ATTACHMENT F2

DEALINGS WITH SRDAC/RMS

**From:** HALL James C [James.HALL@rms.nsw.gov.au]  
**Sent:** Thursday, 27 September 2012 2:21 PM  
**To:** Stan Kafes  
**Cc:** Lindsay Hunt; Peter Hinteregger (Peter.H@pdmayoh.com.au); LIN Xi  
**Subject:** RE: Colombia Precinct - Design Review

**EXHIBITION OF MIXED USE DEVELOPMENT, COLUMBIA PRECINCT  
2-20 PARRAMATTA ROAD & 11-13 COLUMBIA LANE, HOMEBUSH**

307636-SK16

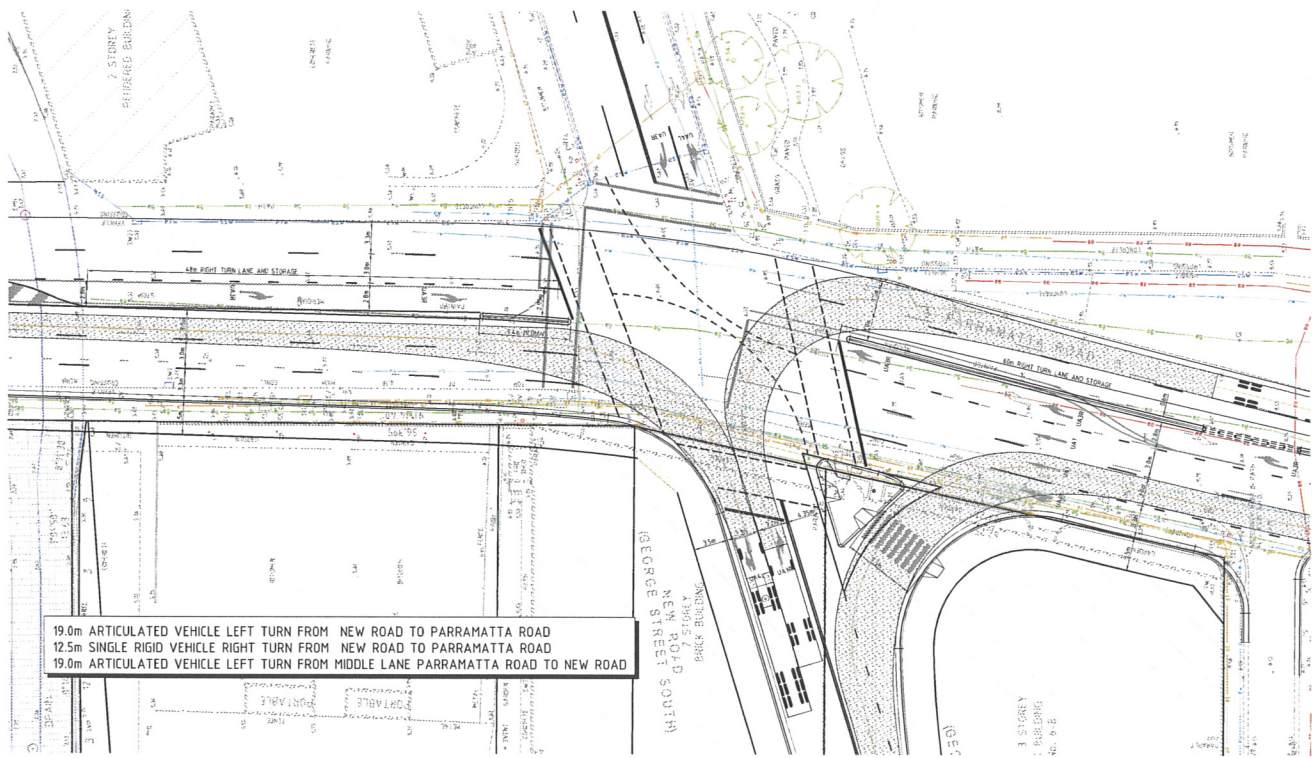
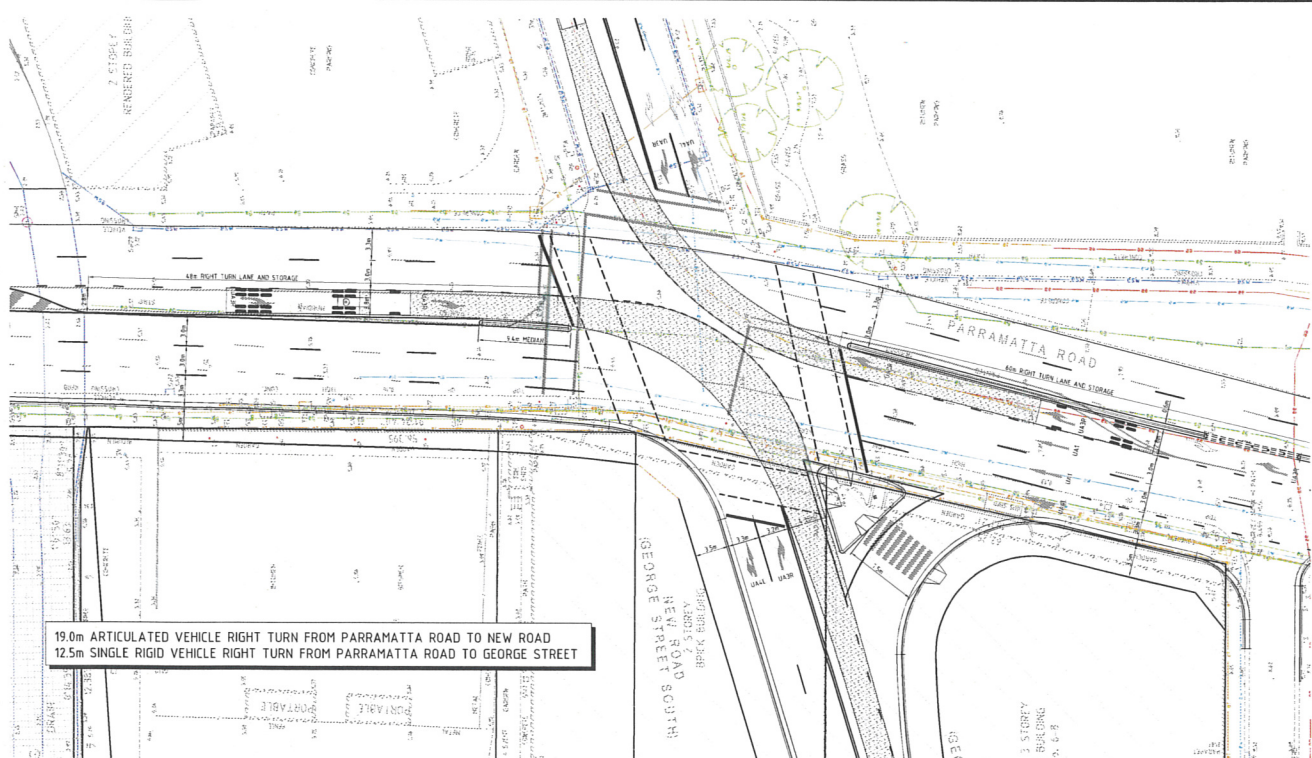
- The turn paths shown are acceptable. No turn path is shown for a 19.0m semi-trailer turning right out of George Street South. Is a semi ever expected to do this turn? If the vehicles and turn paths as shown are what is to be expected then it is acceptable geometry wise. And if any changes need to be made it is only a matter of moving median noses and stop lines, nothing dramatic.

- The right turn lanes are now a constant 2.8m in width, which is acceptable. However, it would probably be advantageous if they showed how all signal hardware is to be located so as to prove everything can be fitted. Because we don't want the situation where road geometry is approved and then finding when the TCS plan is prepared that signal hardware won't fit. And then having to change the geometry. It doesn't have to be a full on TCS plans, just a plan showing what is proposed and will it fit.

- The island kerb face in Parramatta Road needs to be moved back at least half a metre as it is line with the lip of kerb east of the intersection. And the pedestrian crossing in Parramatta Road on the western side has been angled more and as such it has been increased in length. This issue (if an issue) along with other minor issues can be addressed in the the detailed design and TCS design stage as it won't affect the overall geometry.

Please find attached the revised concept layout plan and swept paths for the intersection of Parramatta Road and George Street prepared by Mott MacDonald. As requested, the intersection layout has been modified to include a 2.8 metre right turn storage lane in Parramatta Road and to accommodate the swept path of a 19 metre articulated vehicle turning right into George Street South from Parramatta Road.
